NAVIGATION - GARMIN SOFTWARE UPDATE TO VERSION 4.8.11

525 (Citation M2)

SB525-34-97
Page 1 of 3

Figure 1. Wiring Modification (Sheet 2)

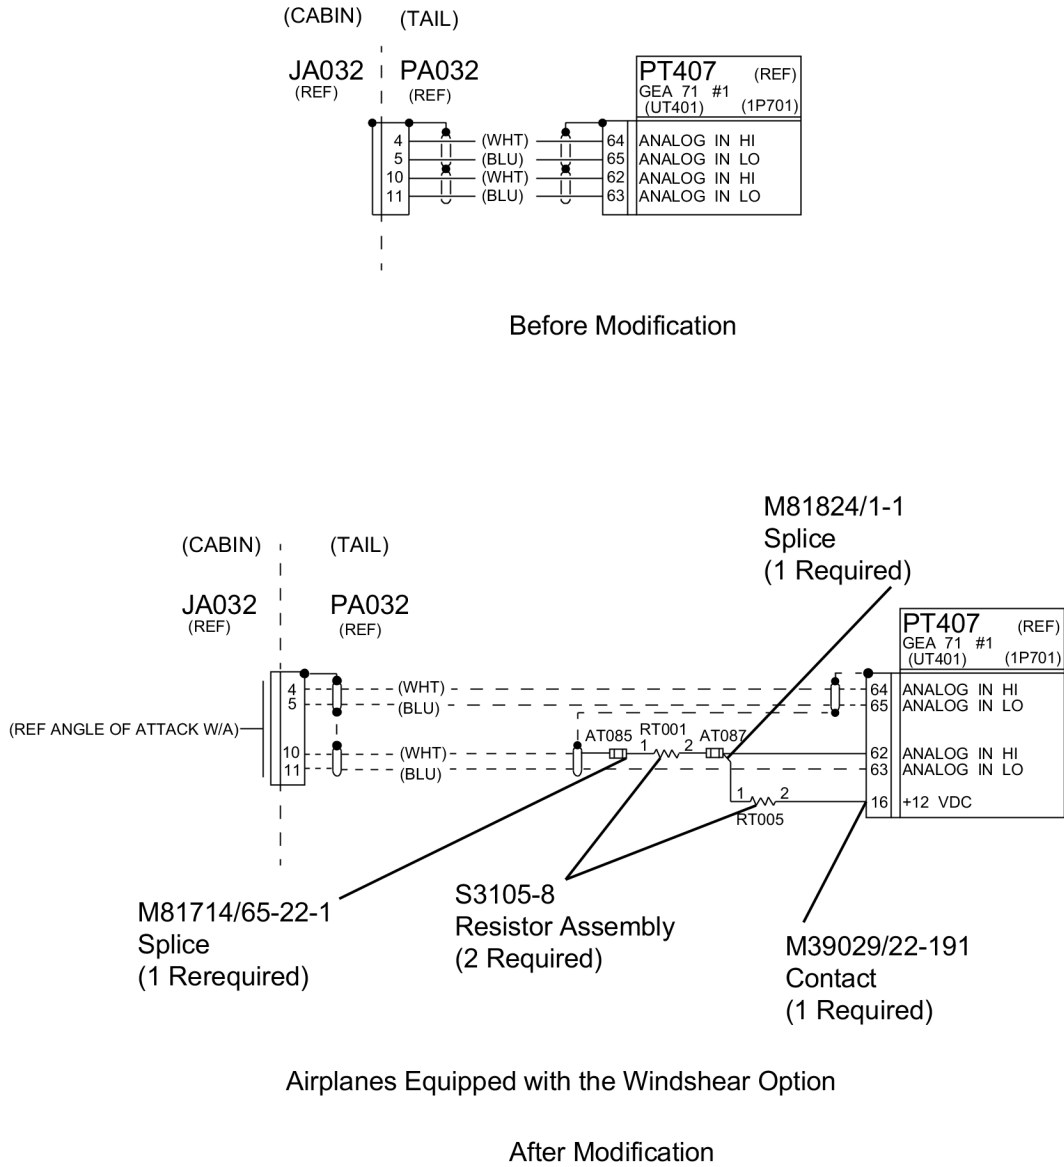
- I. (Refer to Figure 1, Sheet 2.) Install the 77J3-70P606 Electrical Wire using two M39029/58-362 Connector Pins.
 - J. Install the PN836 electrical connector in the Stormscope processor.

- M. Engage the NAV IAU 1 and the COMM 1 circuit breakers on the right circuit breaker panel in the cockpit.
3. (Airplanes equipped with the Windshear option) (Refer to Figure 1, Sheet 2.) Install two S3105-8 Resistors.

NOTE: Install the resistor modification within six inches of the PT407 connector.
